**BID NO. 24-013
WIC CENTER RESTROOM RENOVATIONS**

ADDENDUM NO. 1

May 29, 2024

WOMEN'S & FAMILY RESTROOM

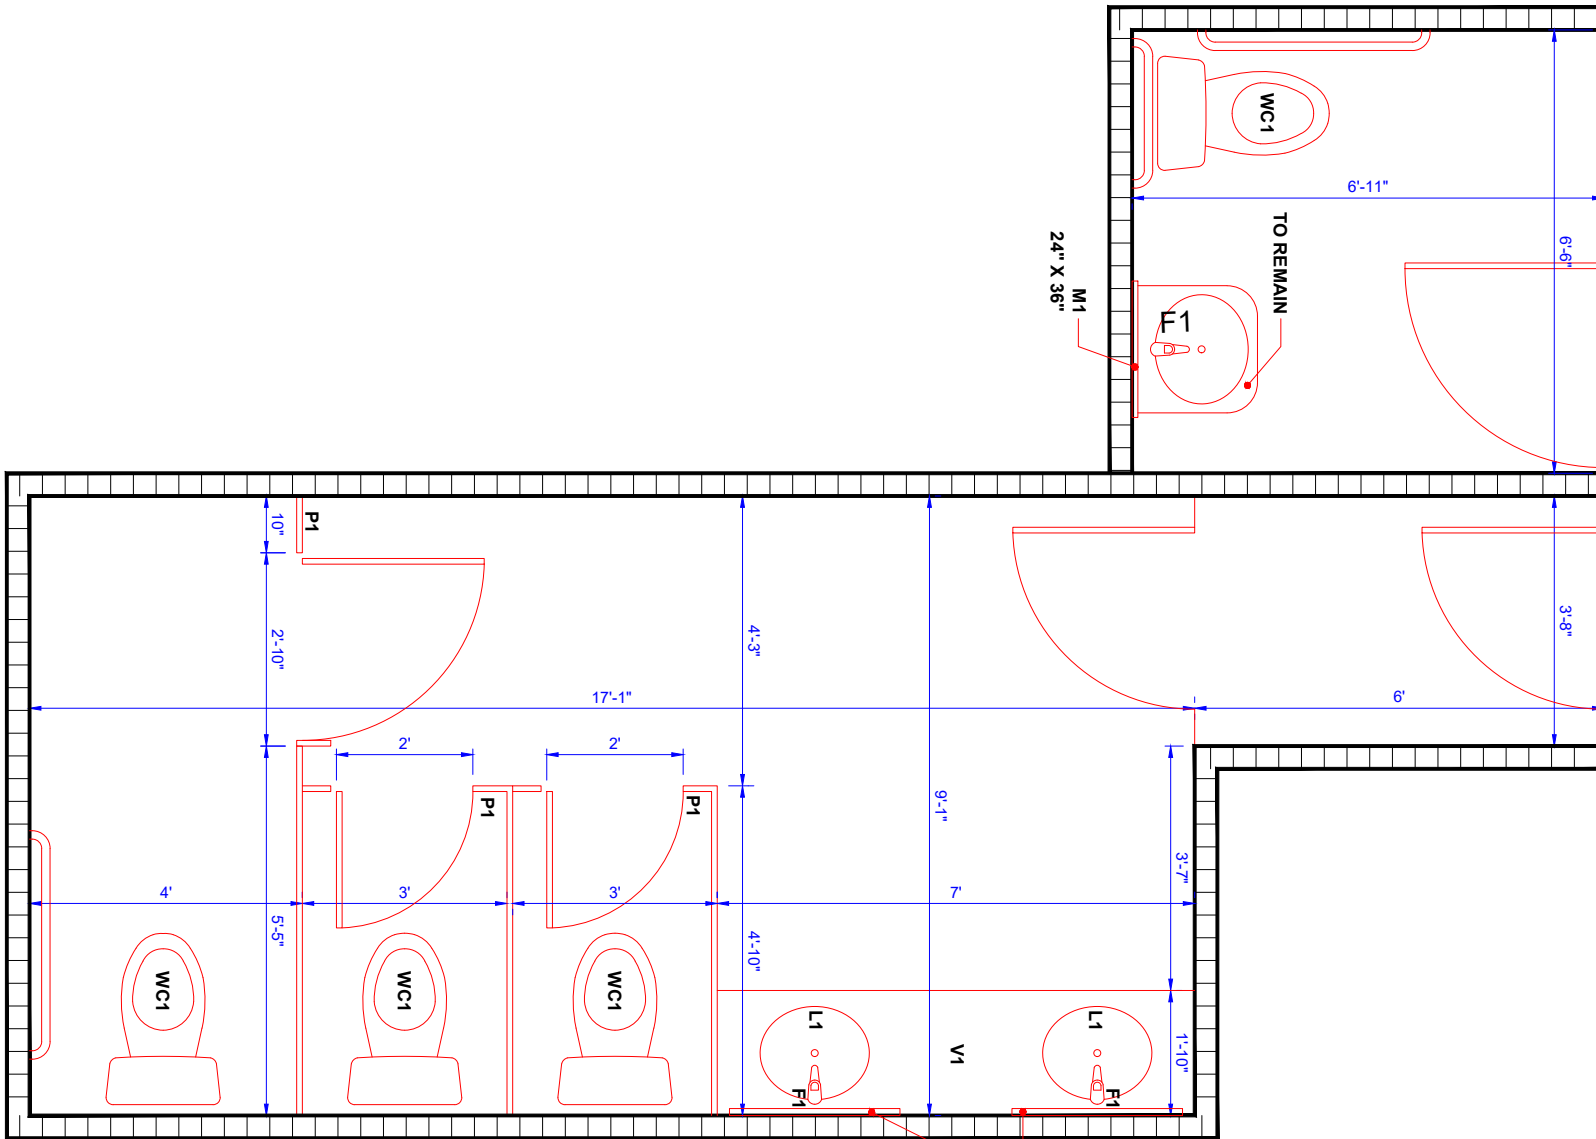
1. Attachment B Women's & Family Restroom Layout has been updated.

The attached updated plan shows:

- Adding one F1 faucet to replace existing faucet in the family restroom.
